MEMORANDUM

Date: August 23, 1995

To: Mr. John Austin
U.S.NRC
Washington, DC 20005

From: Linda Lehman
1103 W. Burnsville Parkway
Suite 209
Burnsville, MN 55337

Figure 1. Water table temperature contours in degrees C (Sass et al 1988).

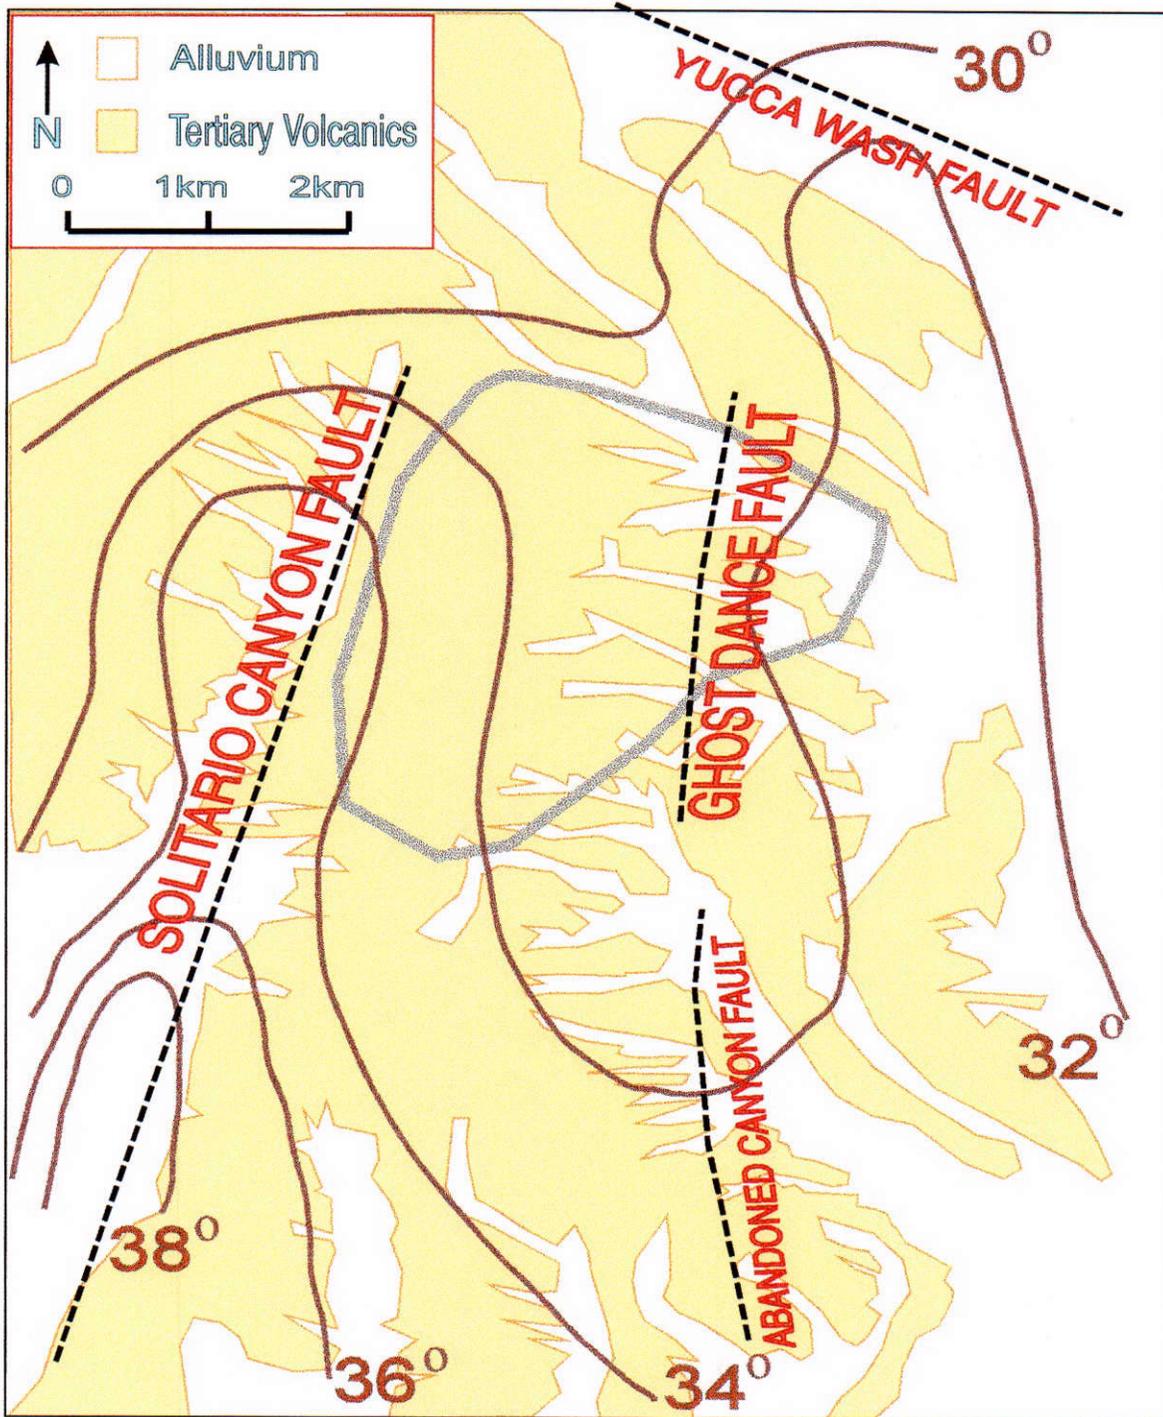
Temperature is also an important parameter to match in flow modeling in both the saturated and unsaturated zones. Figure 1 is a map of the temperature contours at the water table in the vicinity of Yucca Mountain. As can be seen, a cold temperature spike appears to be coincident with the strike of the Ghost Dance Fault. This may indicate that colder water is moving across the steep hydrologic gradient, which exists in the northern part of the site, via fracture zones and is transmitted to the south. A high temperature area can be seen to the west of the mountain and occurs in close proximity to the volcano area and seems to also parallel the Solitario Canyon Fault zone. Any modeling of the saturated zone flow field should be able to account for this temperature field.

Figure 2. USGS preliminary saturated zone potentiometric surface (Robison, 1984).

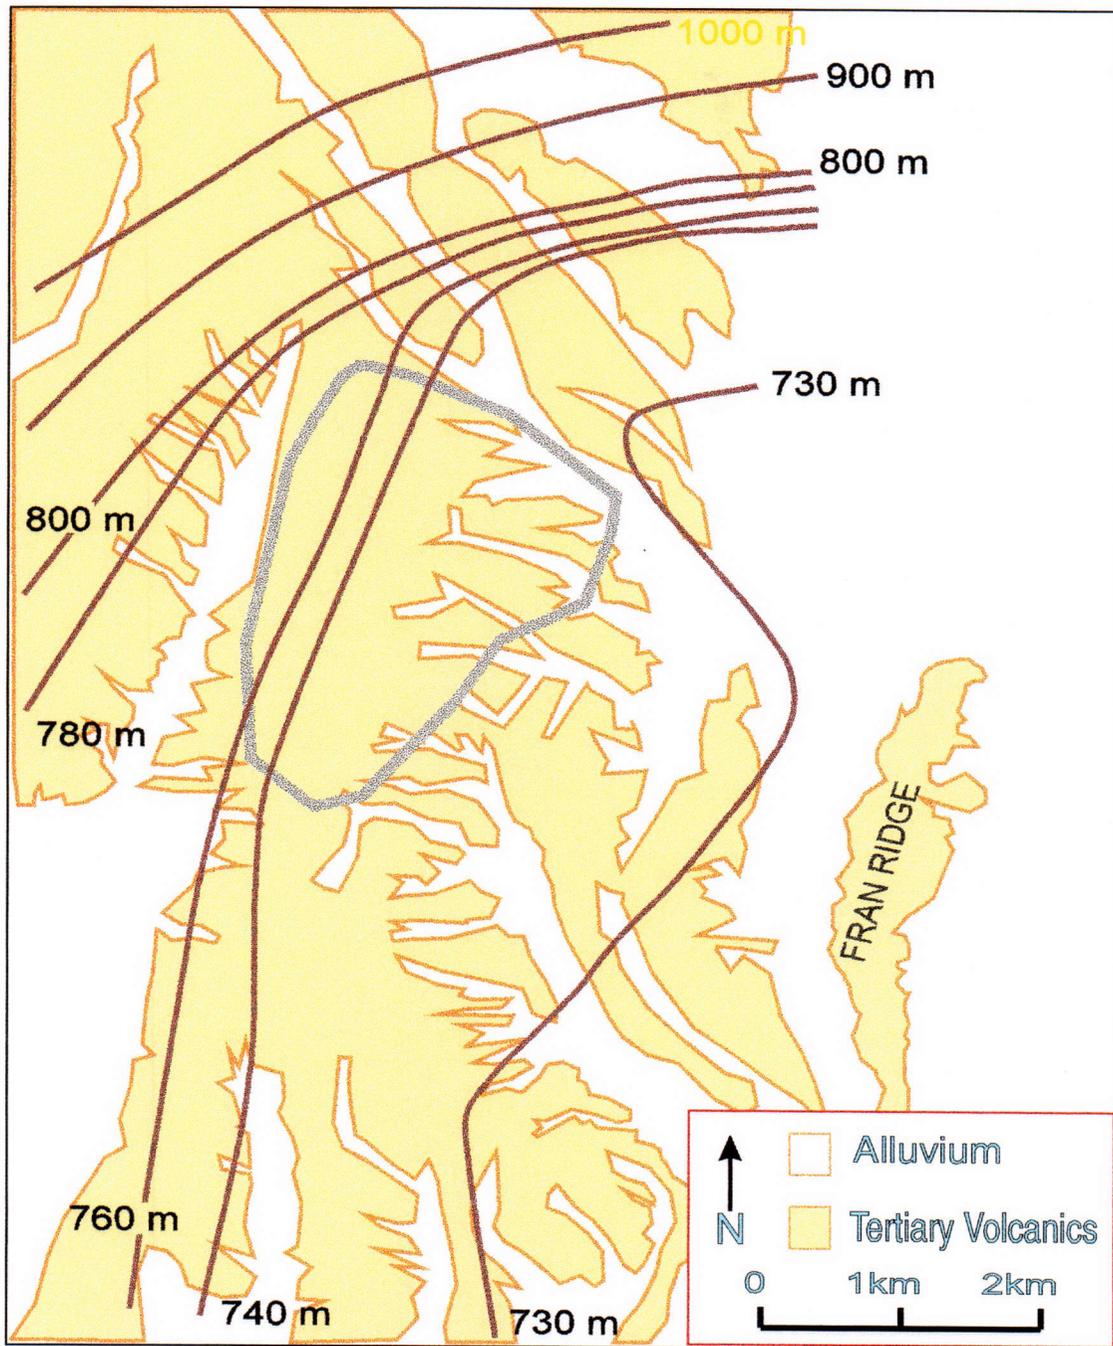
3. An early version of the potentiometric surface was published by the USGS in Robison, 1984 and is shown as Figure 2. This map indicates two embayments in the 730 meter contour of

the potentiometric surface: one in the location of the Drill hole Wash Fault, a known fault zone, and the other embayment to the south of the repository footprint. This map was subsequently revised by the USGS in 1994, after making corrections for temperature, elevation and density. This revised map from Erwin, et al 1994 is shown as Figure 3. As can be seen the sharp embayment near the Drill Hole Wash fault has disappeared and two other small embayments exist closer into the repository. They can be seen primarily in the 730.5 meter contour line. Checking data from which this figure was constructed (listed on page 15 of Erwin et al, 1994) it can be seen that all the revised data were not used in the revised potentiometric surface map. Figure 3 shows the revised data labeled in red which were not used and are not consistent with the mapped potentiometric surface. The authors reasons for not including these revised head data were stated on page 14, paragraph 2 as follows:

Figure 3. USGS Revised saturated zone potentiometric surface (Ervin, Luckey and Burkhardt, 1994). Red labels indicate adjusted data inconsistent with surface.

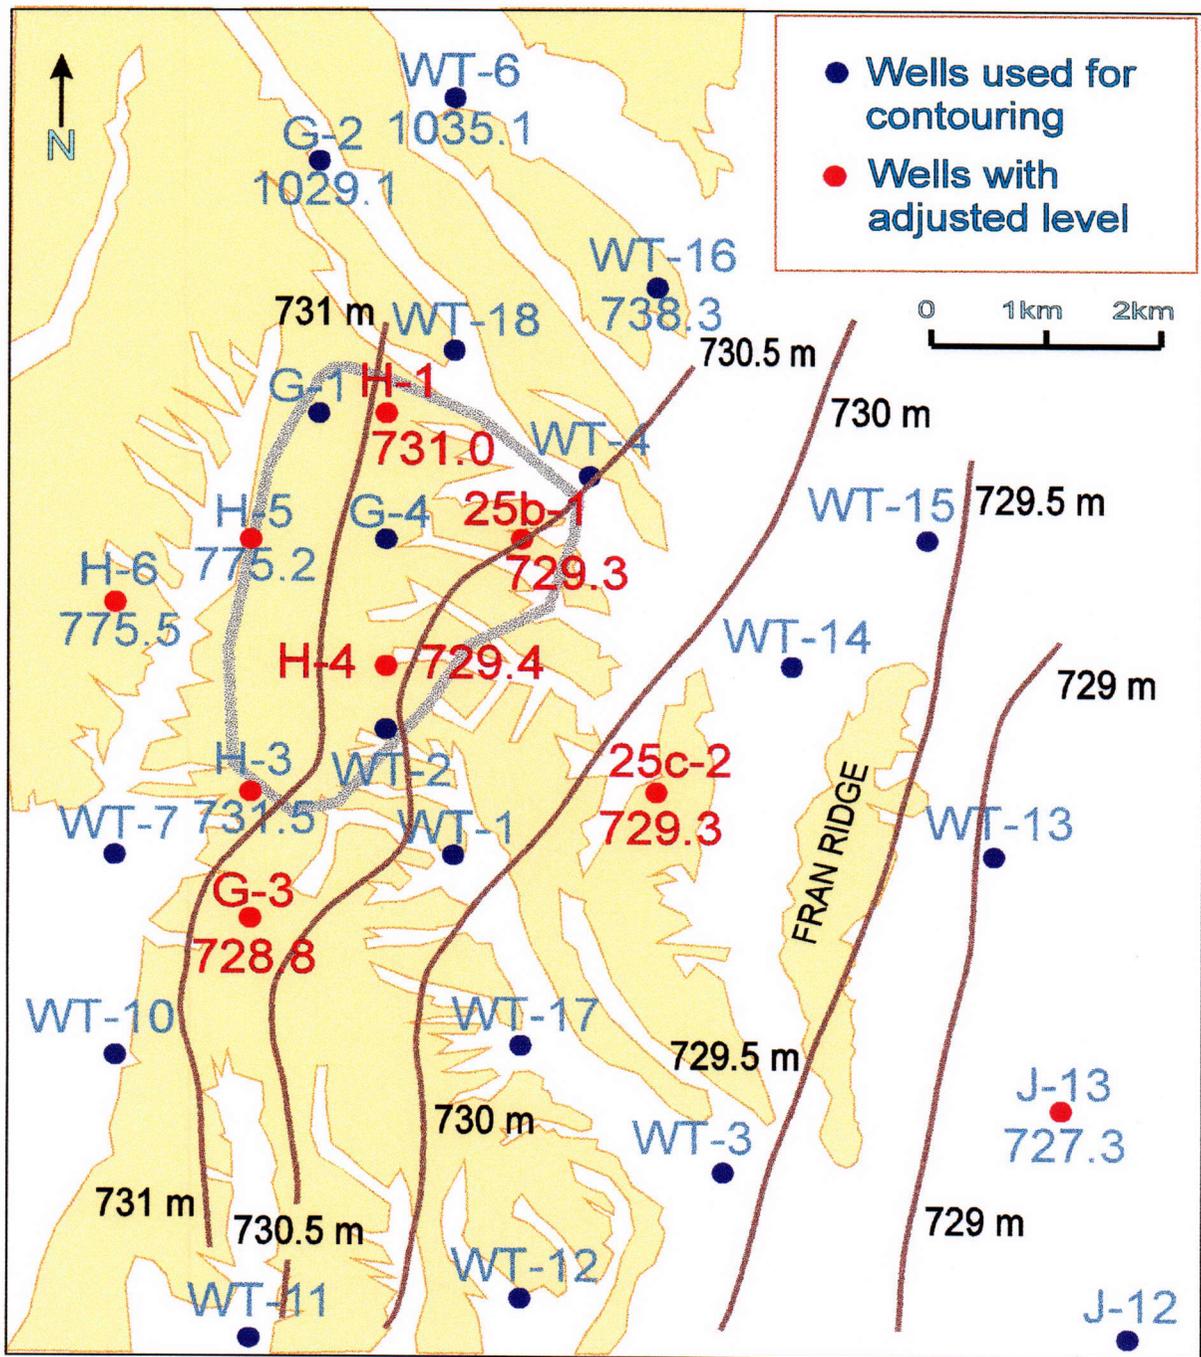
"Adjustments for wells UE25 b-1, USW H-4, UE 25 c2, and UE 25 c3 produced lower water levels and when plotted created an apparent water level low in the middle of the revised potentiometric-surface map. No physical reason could be found for this feature. Thus, none of the adjusted water level values were used in the revised potentiometric-surface map."

The flow field interpretations just described are quite different from interpretations which would result from utilizing the Erwin et al., 1994 USGS potentiometric surface map. We feel that this saturated zone potentiometric map is not accurate and does not include adjusted data points which we believe are crucial to the interpretation of ground water flow paths and therefore GWTT. These data need to be examined by the NRC in detail before accepting the potentiometric surface or using it for calibration of ground water models. We urge the NRC to make their own investigations into the potentiometric surface interpretation, as conceptual models are often the primary cause of model uncertainty in GWTT and transport calculations.

Figure 4. Alternative potentiometric surface with fault locations and resulting flow pathways.

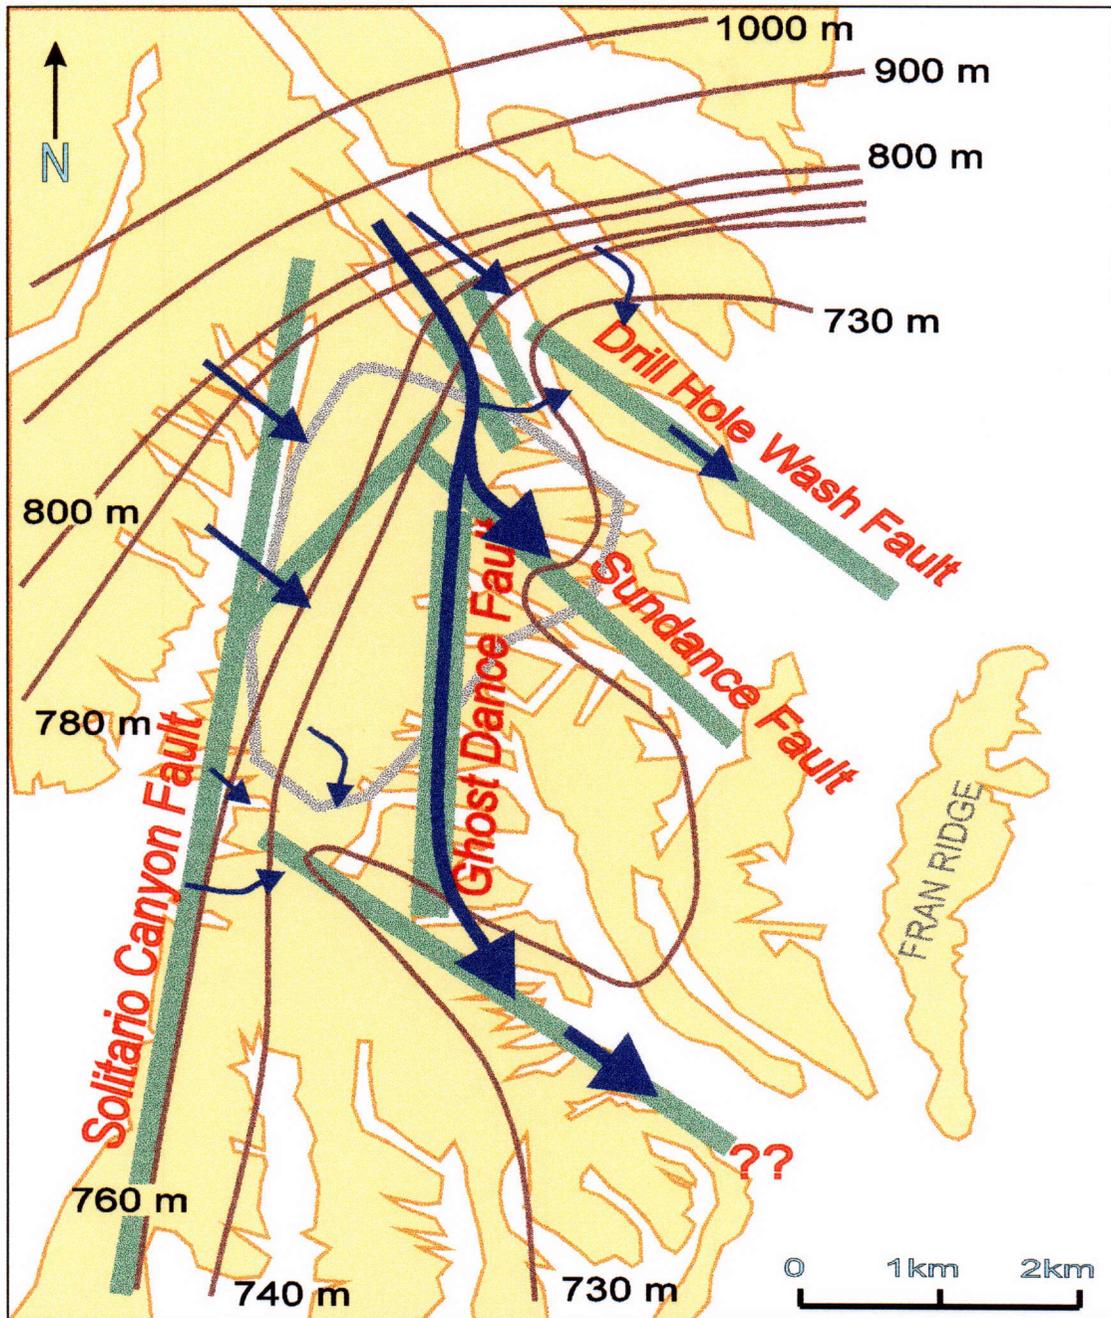
Rather than discard field data, L. Lehman & Associates subsequently re-plotted the complete set of revised head data and the result is shown as Figure 4. As can be seen, there are now three embayments, two of which are coincident with two known fault zones: the Drill Hole Wash Fault and the recently discovered Sundance Fault. These embayments suggest that the faults are hydraulically significant. These faults may be acting as either conduits or channels for groundwater flow or as less permeable features which are displacing the 730 meter contour. Based on the assumption that the fracture patterns at Yucca Mountain are fractal (Barton and Larsen, 1985) and therefore would be self-similar and repeating, another northwest trending fault can be predicted to exist at the location of the third and lower most embayment. This embayment is quite deep and may stretch to the Solitario Canyon fault zone. As such it may be indicating a pathway for interbasin flow, just south of the repository footprint. This area remains largely unmapped. The eastward bulges in the 730 meter contour line of Figure 4 may alternatively be indicating areas of recharge (recharge mounds) down the extensional zone of the Ghost Dance Fault.

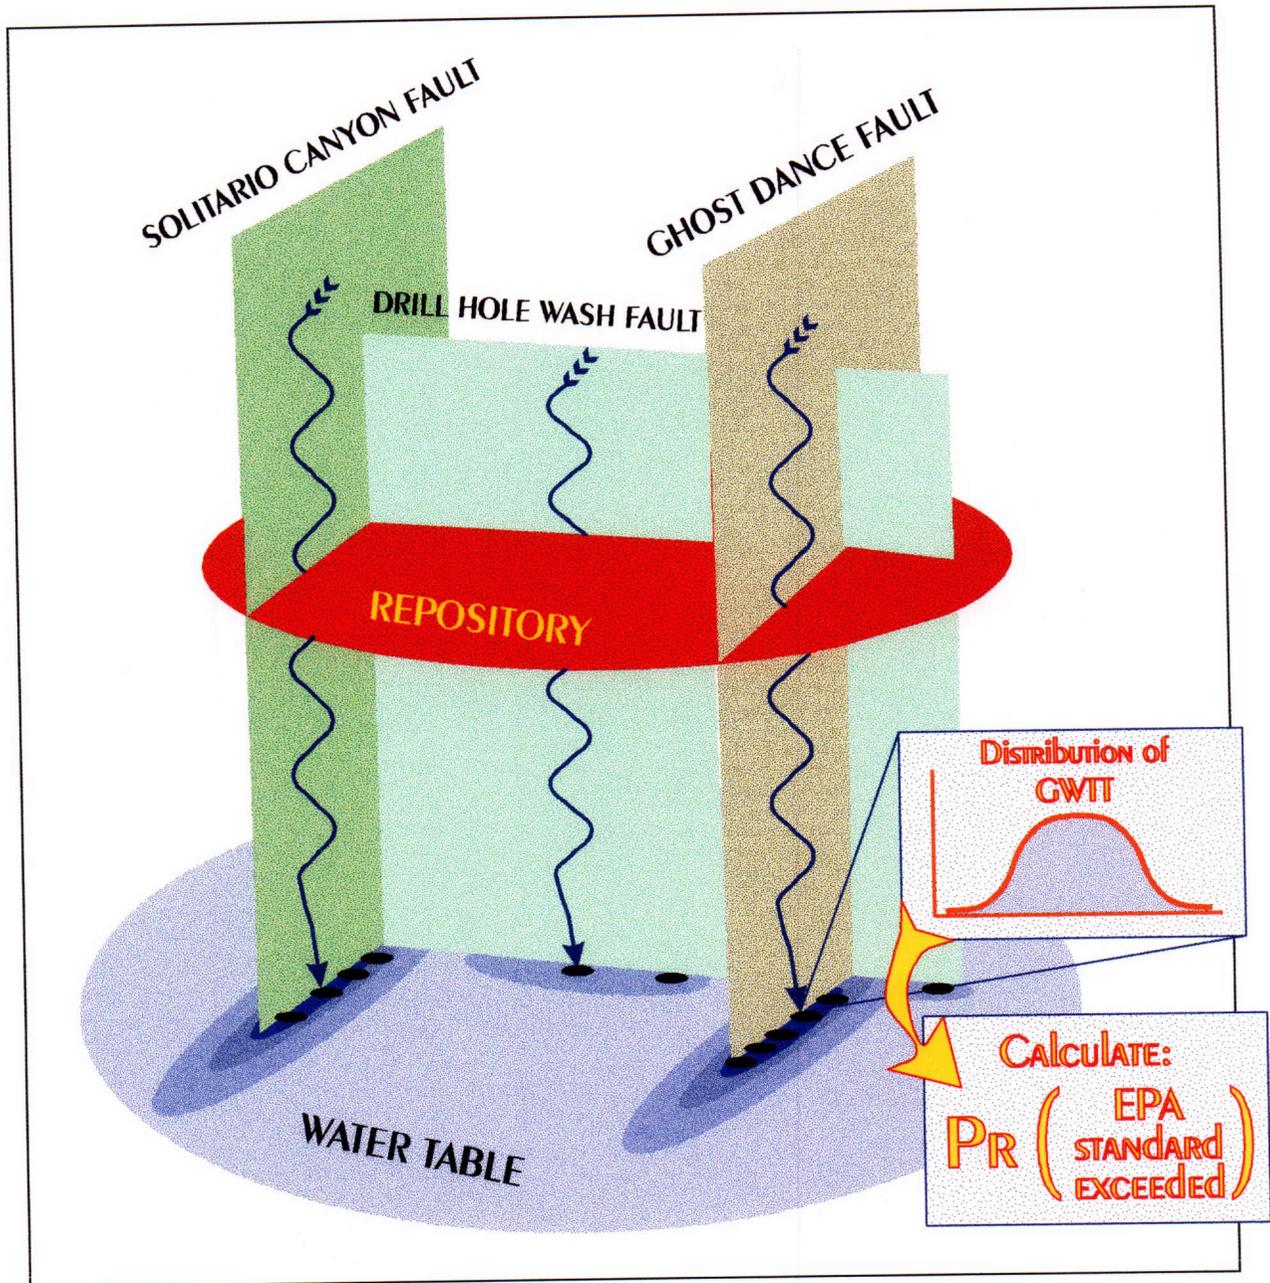
These pathways would then be translated to a surface (Chesnut's concept) perhaps a section below the repository or at the water table where each pathway would be a point on this surface. The distributions of points on this surface would form a pattern of GWTTs, for example as in Figure 5. Probabilities of exceeding the EPA standard could then be calculated at this surface. In this fashion zones which exceed the standard are defined. This could lead to the disqualification of zones rather than the disqualification of the entire repository, if some zones are likely to exceed the standard.
